Proposal for SAS 2.x Specification to Enable Support for Active Cables

Gourgen Oganessyan

QUELLAN

July 11, 2008

Figure 98 — Mini SAS 4x cable plug connector that attaches to an enclosure universal port

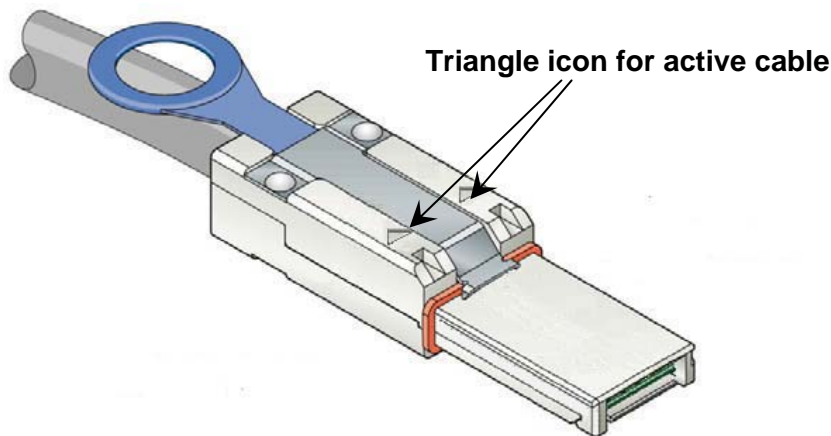
In order to ensure that active cables cannot be plugged into legacy (passive) ports, differentiating keying shall be provided by removing all the key slots from the plug connector and all the keys on the receptacle connector. In addition, two triangle icons on each side on the plug connector will be added to the plug connector to distinguish an active cable assembly (Figure 98).

Figure 98 shows an active mini SAS 4x cable plug connector that attaches to an enclosure universal port:

Figure M.1 — Dual comparator design for active cable detection

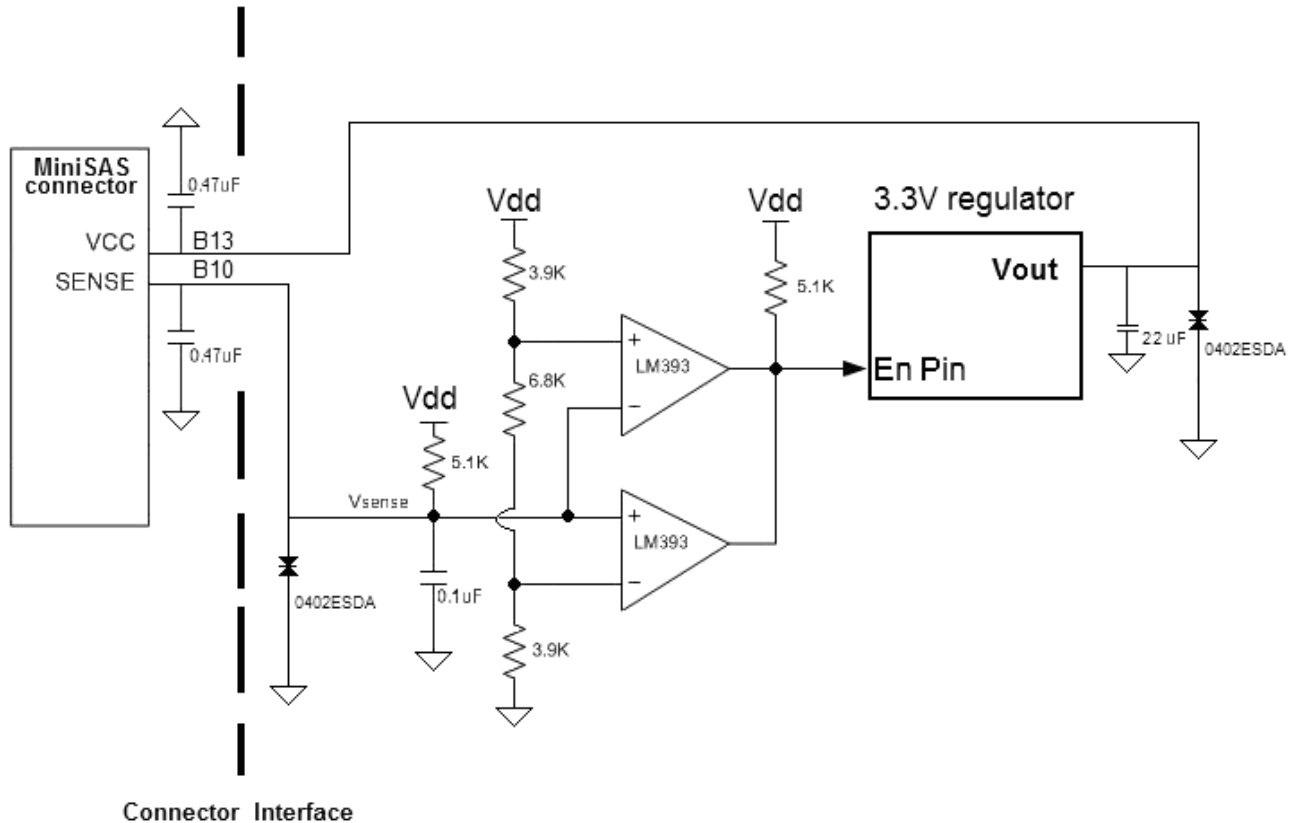
Due to the fact that powered mini-SAS equipment supporting active cables needs to be able to operate with passive cables which have the Vcc pin tied to ground, there needs to be a mechanism that turns on the power to the port only when an active cable is plugged, to avoid shorting the power supply. A voltage sense pin is implemented to detect if an active cable is in operation. This can also be used to detect the status of a specific port, or implement other features within a switch device.

The following is a reference design utilizing a dual comparator to determine from the sense pin on the cable if an active cable is in operation on a specific port. The circuit then supplies power based upon whether there is an active cable connected to the specific port.
